Number: FS-2012-05

Subject: Exhaust System Flex Pipe Change

FIELD SERVICE BULLETIN

For replacement of Red Silicone (Linkeo) exhaust bellows with All Metal (Tru-Flex) exhaust bellows on 2010 Emissions year engine equipped buses

FIGURE 3. ISL-G CNG ENGINE

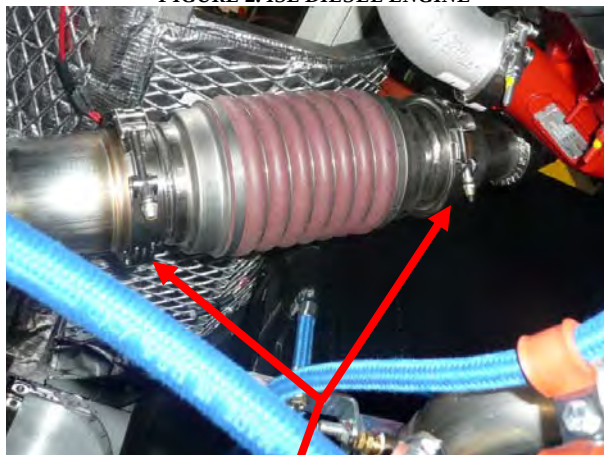
1. Remove the existing red silicone exhaust bellows from the bus by loosening the two V-Band clamps.

LOOSEN V-BAND CLAMPS
SHOWN TO REMOVE THE
EXISTING BELLOWS
(CLAMP LOCATION "C")

FIGURE 6.

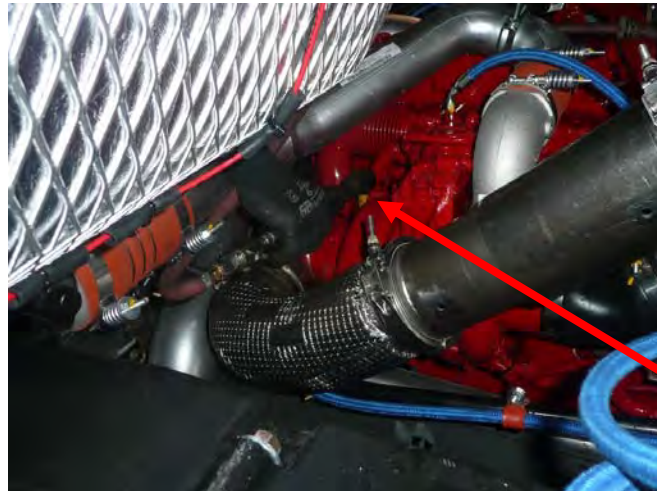
2. Insert the alignment tool between the turbo outlet pipe & muffler inlet pipe (as shown below), tighten the bottom V-Band clamp to approximately 6 ft-lb and align the other end of the tool with muffler inlet pipe.
NOTE: DO NOT FORCE THE ALIGNMENT TOOL TO FIT.

3. Then tighten the upper V-Band clamp to approximately 6 ft-lb.

If alignment tool fits between the pipes with V-Band clamps installed to approximately 6 ft-lb, remove the alignment tool and install new all metal bellows (jump to step 9).

FIGURE 10 & 11. ISL ENGINE SHOWN

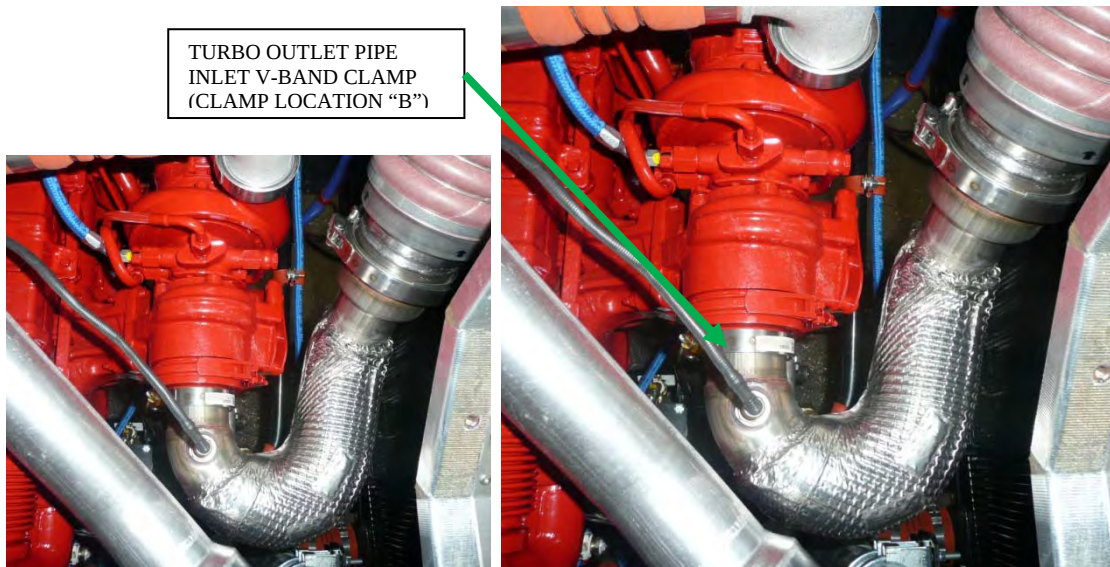
CAST ELBOW AT TURBO
OUTLET V-BAND CLAMP
(CLAMP LOCATION "A")

TURBO OUTLET
PIPE INLET
V-BAND CLAMP
(CLAMP
LOCATION "B")

- CAST TURBO OUTLET ELBOW V-BAND CLAMP *LOCATION "A", SEE FIGURES:
8 & 9 FOR ISB on page 4
10 & 11 FOR ISL on page 4
12 & 13 FOR ISL-G on page 5*
- EXHAUST TURBO OUTLET PIPE V-BAND CLAMP *LOCATION "B", SEE FIGURES:
8 & 9 FOR ISB on page 4
10 & 11 FOR ISL on page 4
N/A for ISL-G*
- ALIGNMENT TOOL UPPER & LOWER V-BAND CLAMPS *LOCATION "C", SEE FIGURE 16 BELOW*
- MUFFLER INLET PIPE V-BAND CLAMP *LOCATION "D", SEE FIGURES:
14 FOR ISB on page 5
14 FOR ISL on page 5
15 FOR ISL-G on page 5*
- MUFFLER INLET PIPE U-CLAMP *LOCATION "E", SEE FIGURES:
14 FOR ISB on page 5
14 FOR ISL on page 5
15 FOR ISL-G on page 5*

FIGURE 14. ISB/ISL DIESEL ENGINE SHOWN

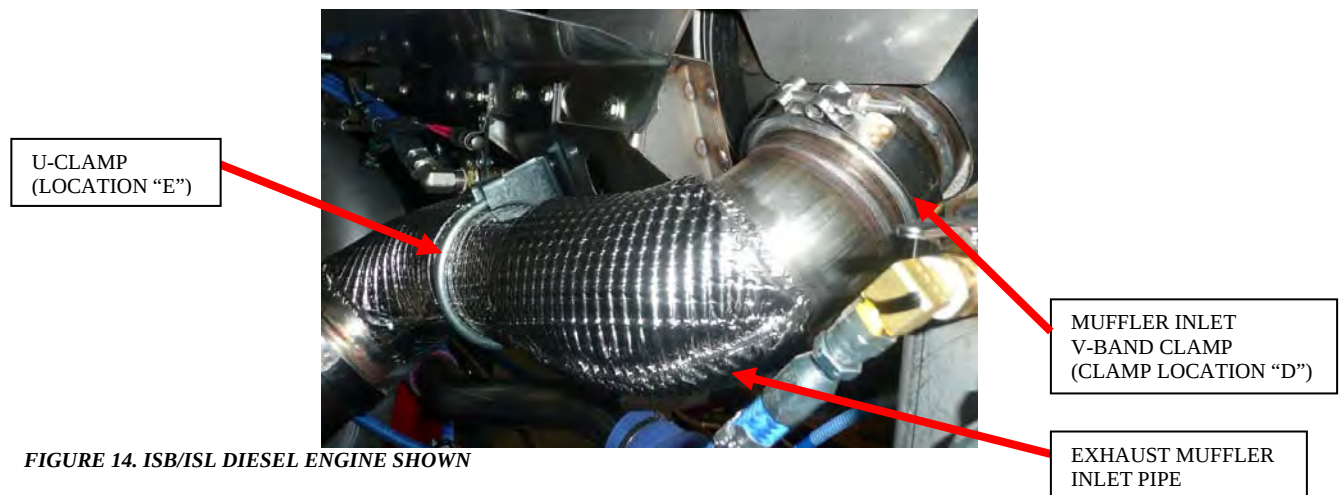
6. Loosen the V-Band & U clamps on exhaust muffler inlet pipe. Loosening the clamps will allow the pipes to move into alignment.
